Re: Cherokee Nation WW Hastings Replacement Hospital - Addendum 02 Narrative

Following is a list of revisions included in Addendum 02.

PROJECT PHASE:
BID PACKAGE 02
(SITE DEMOLITION AND UTILITIES)

JOB NUMBER: 21-08.21
DATE: 10-21-2022
SHEET NUMBER: **C7-210**
SHEET TITLE: **WATER 4 PLAN AND PROFILE**

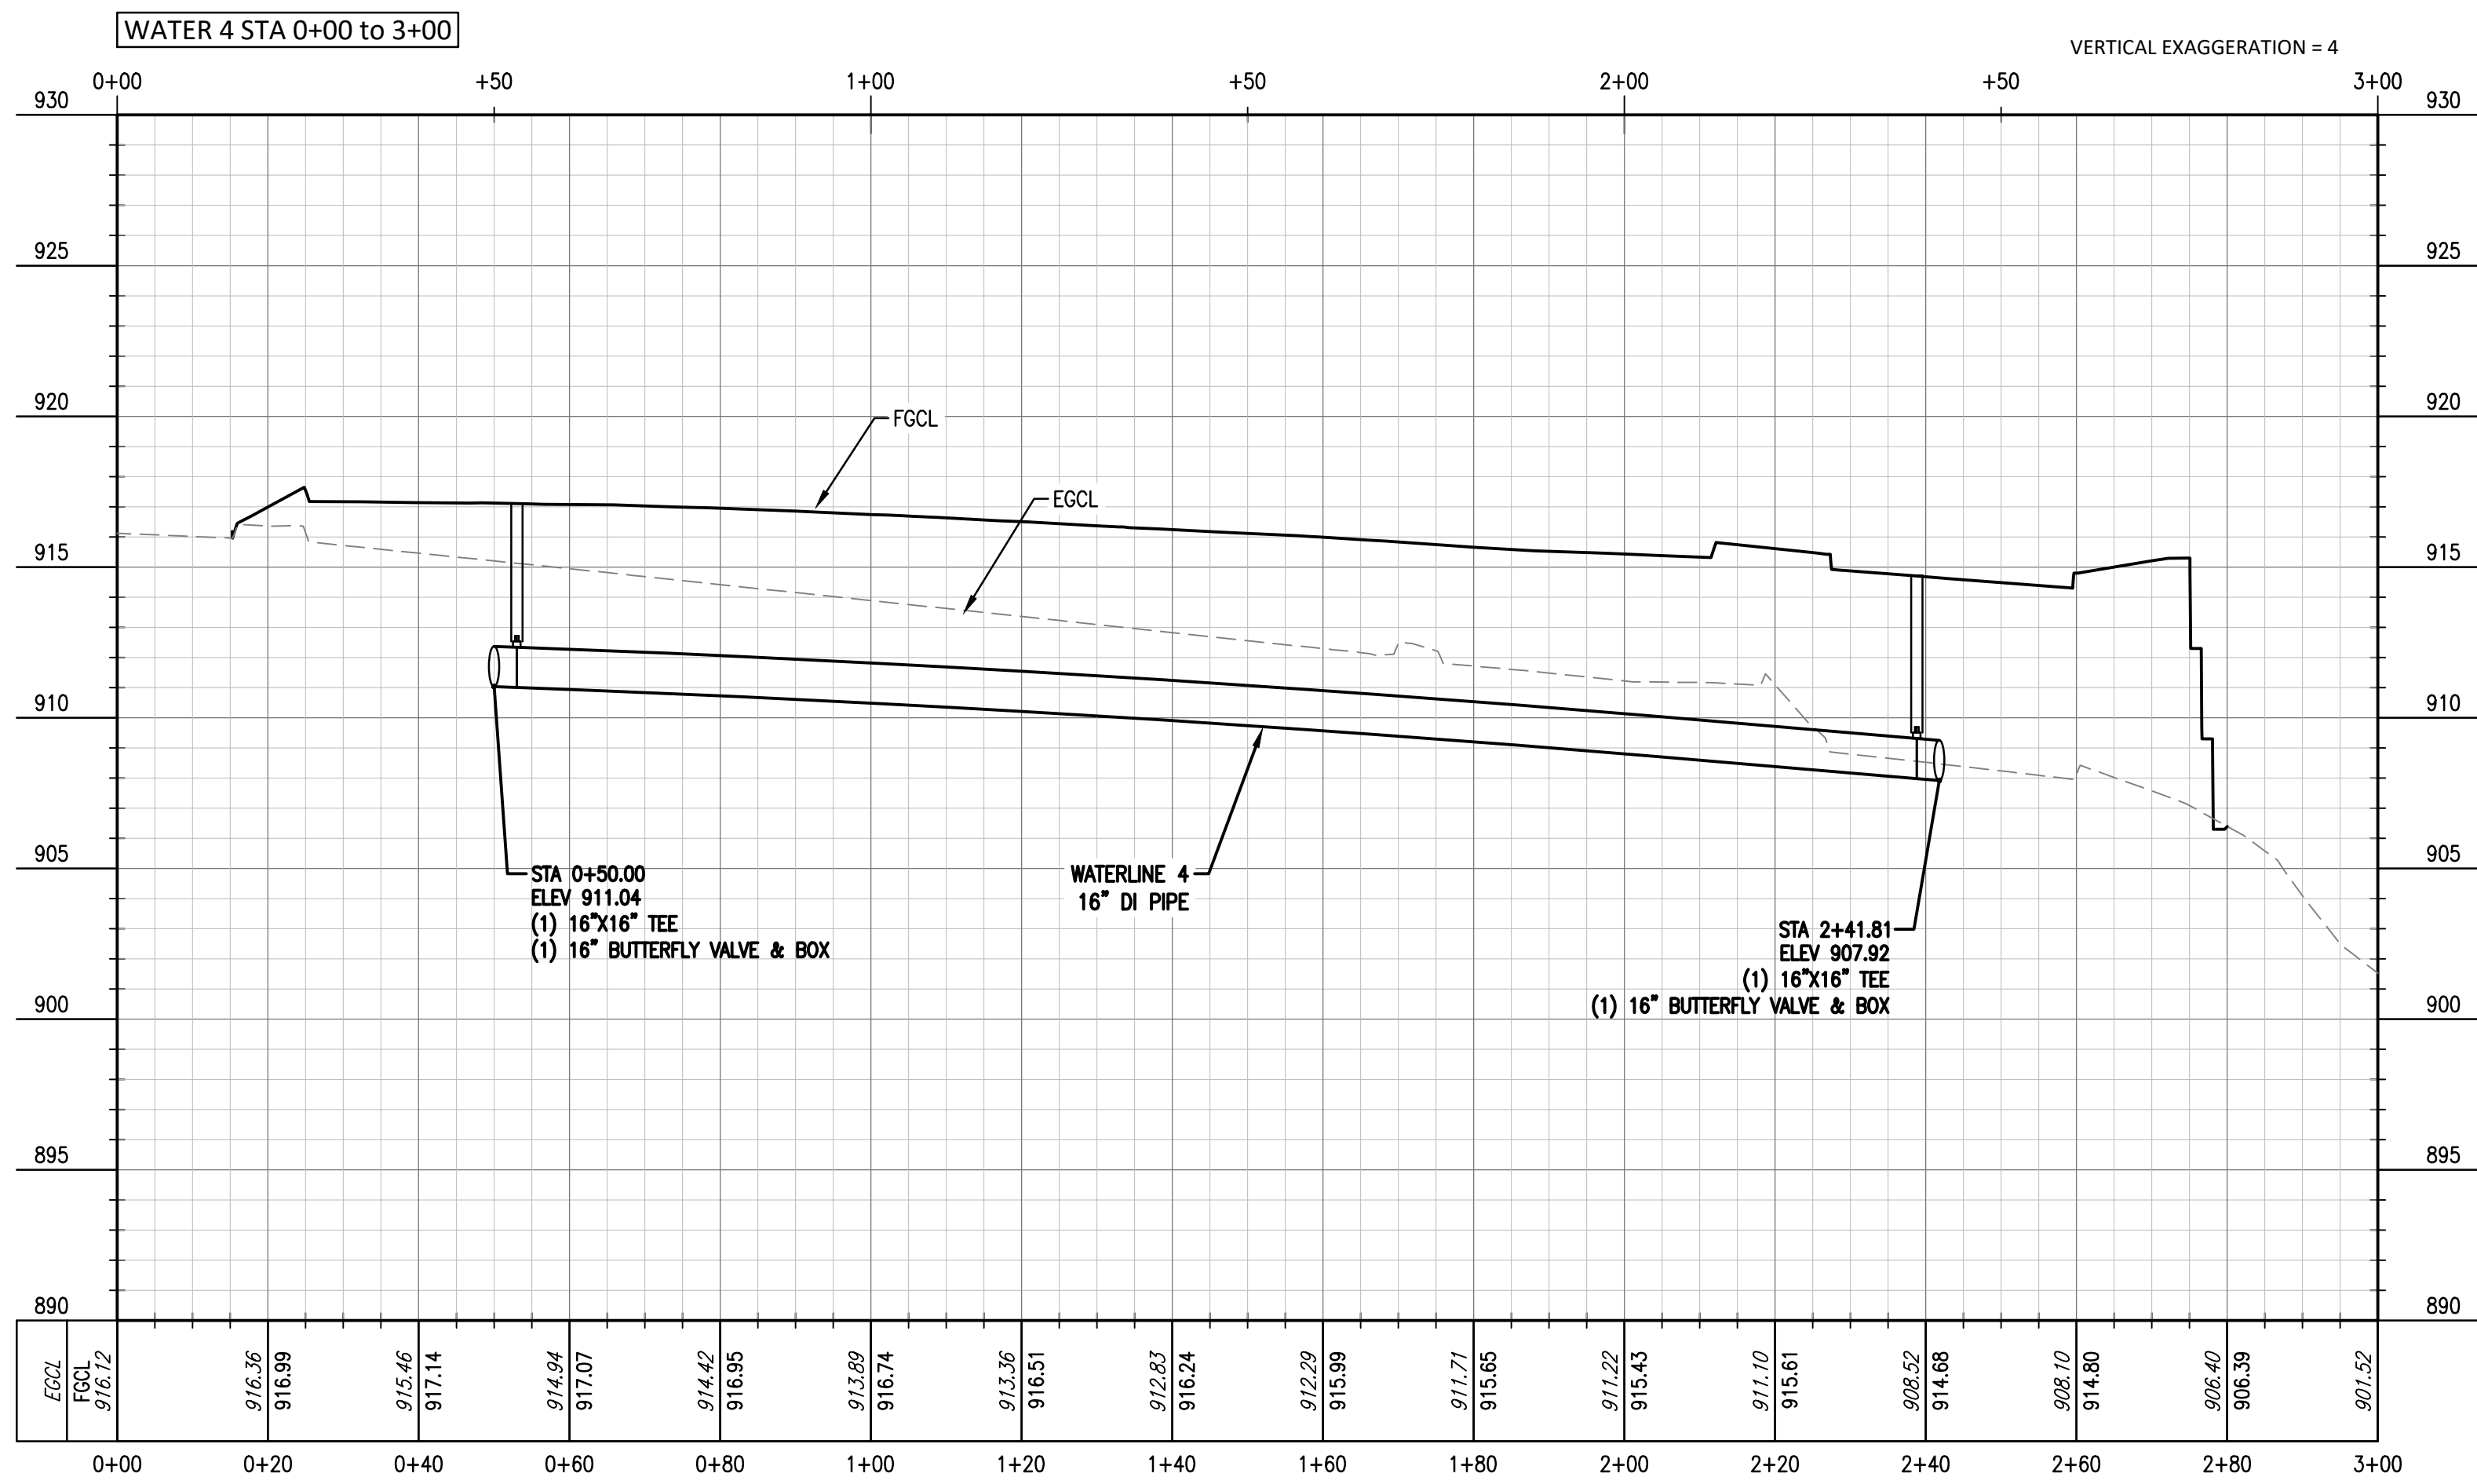
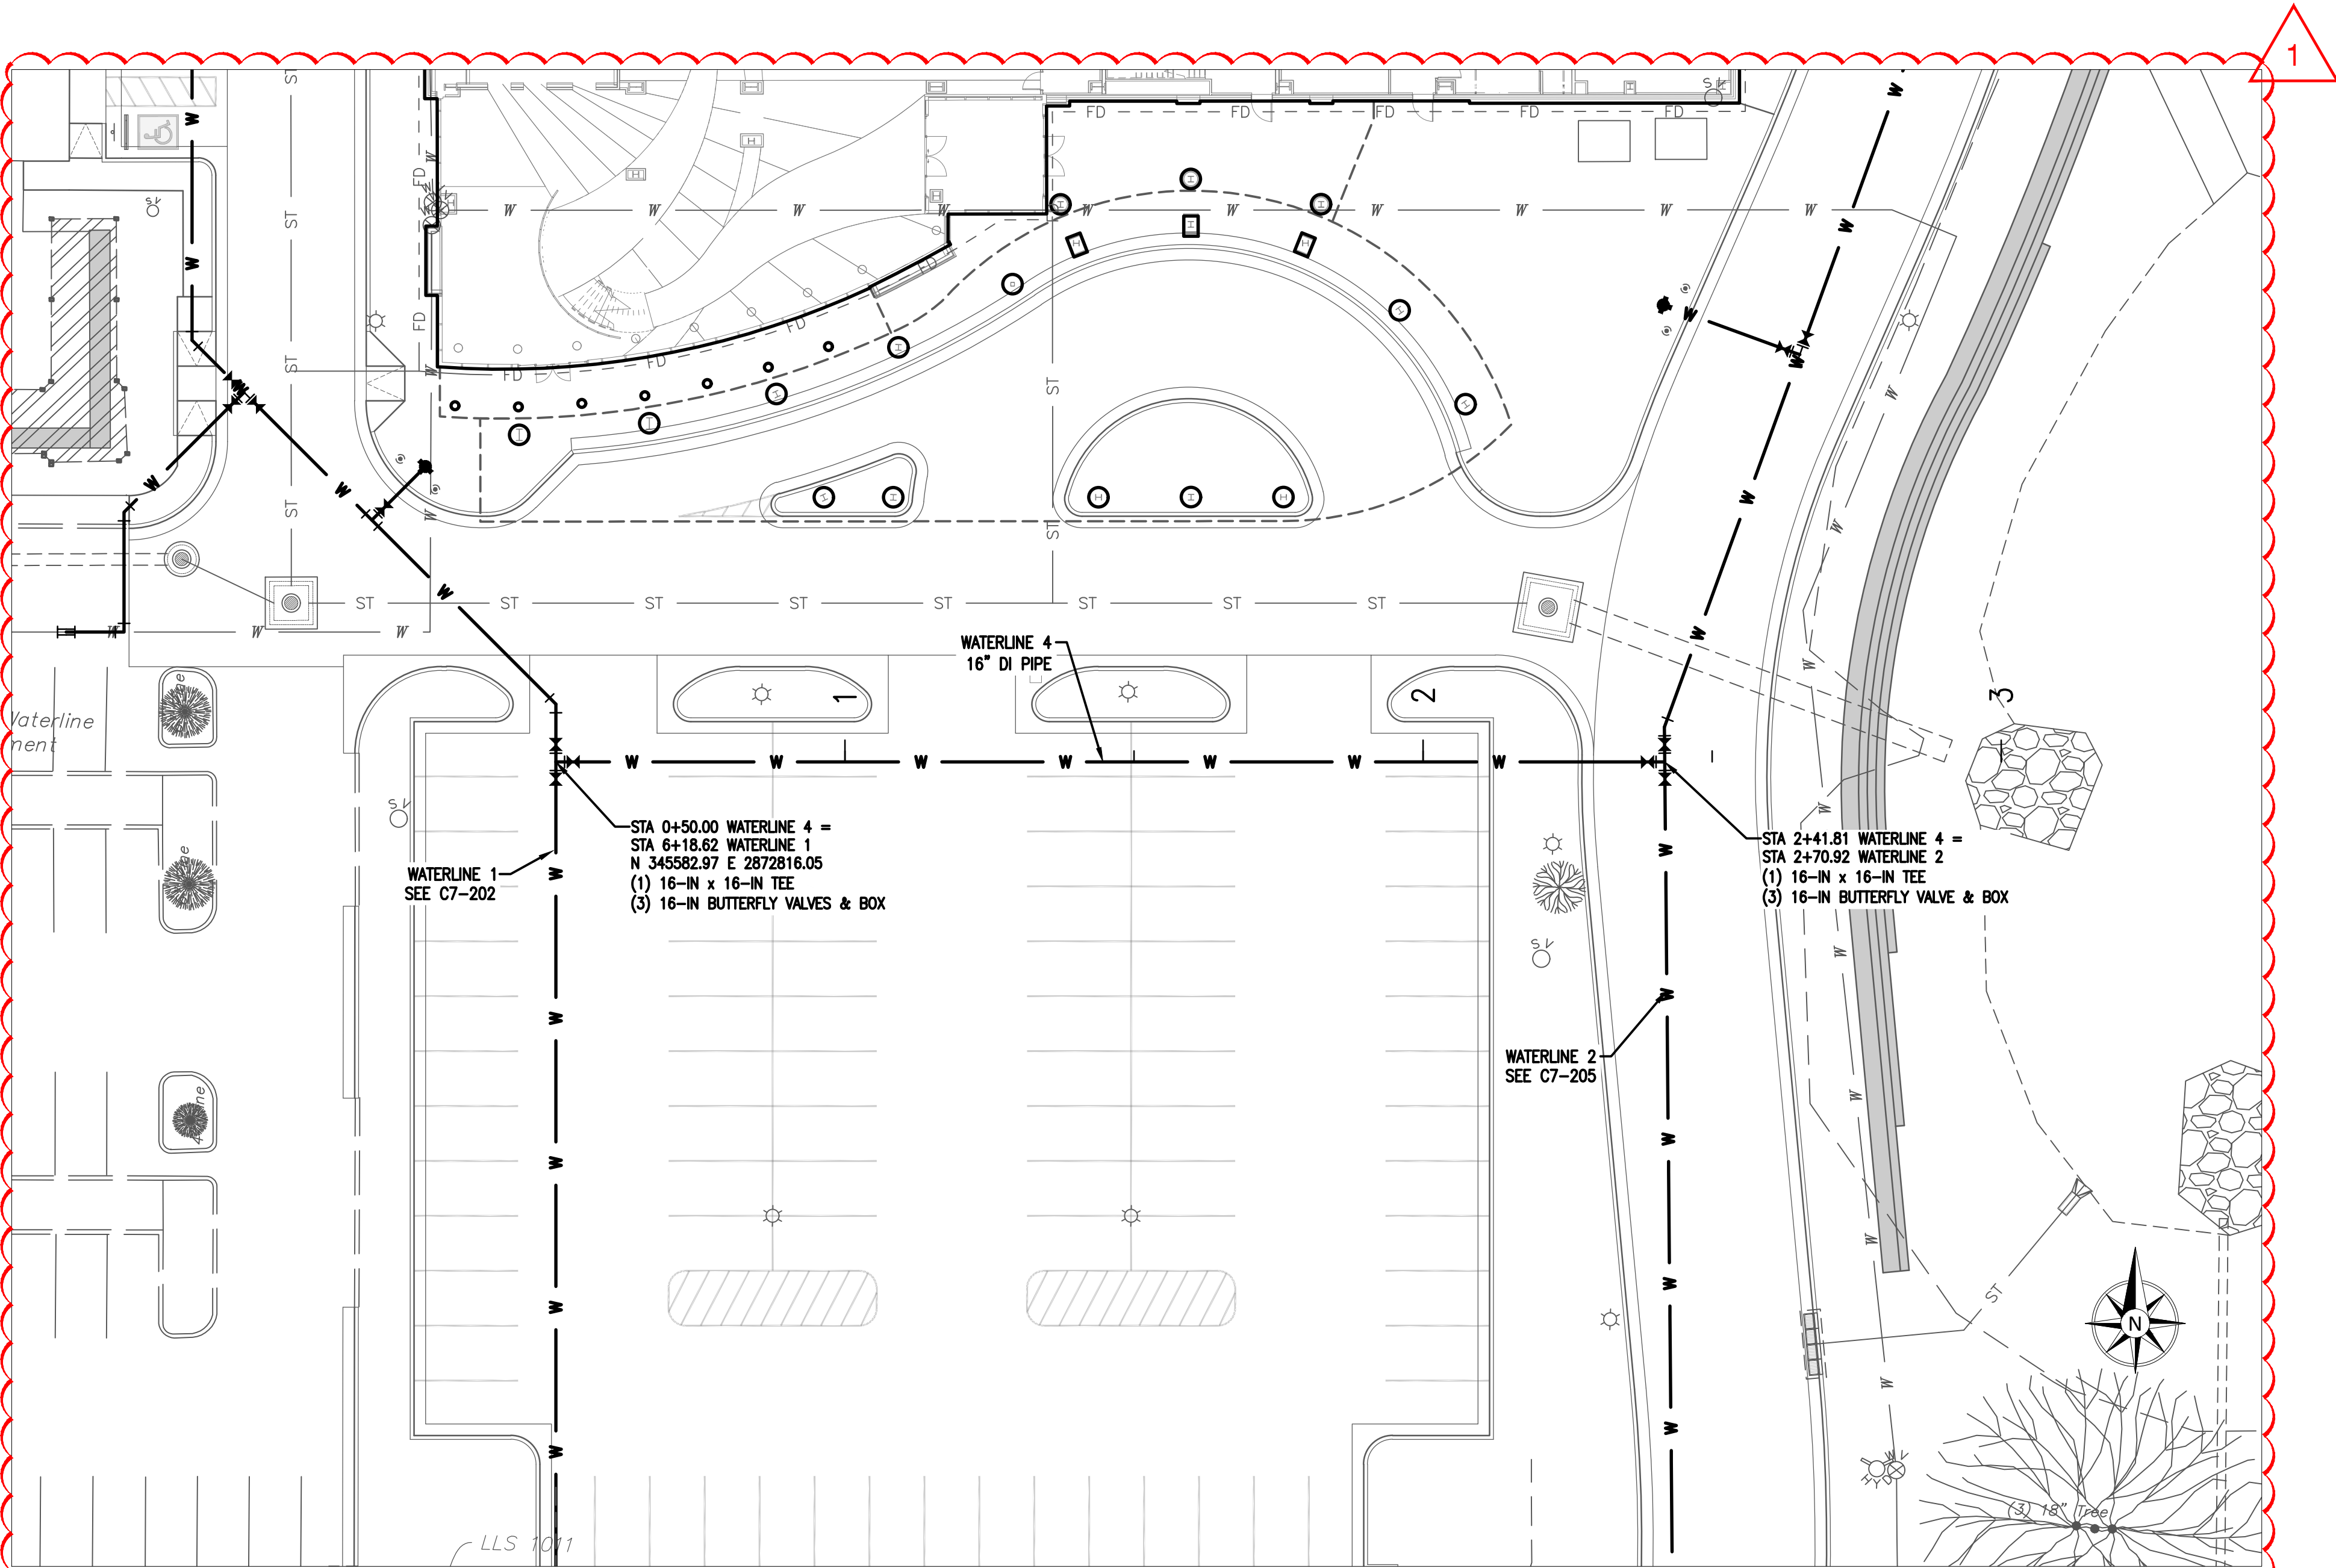
- C7-206 - Added storm sewer crossing pipes to the profile.
- C7-207 - Revised the presentation of the water line in the profile.
- C7-210 - Added label to the plan view.
Revised profile on the east end to match the plan view.
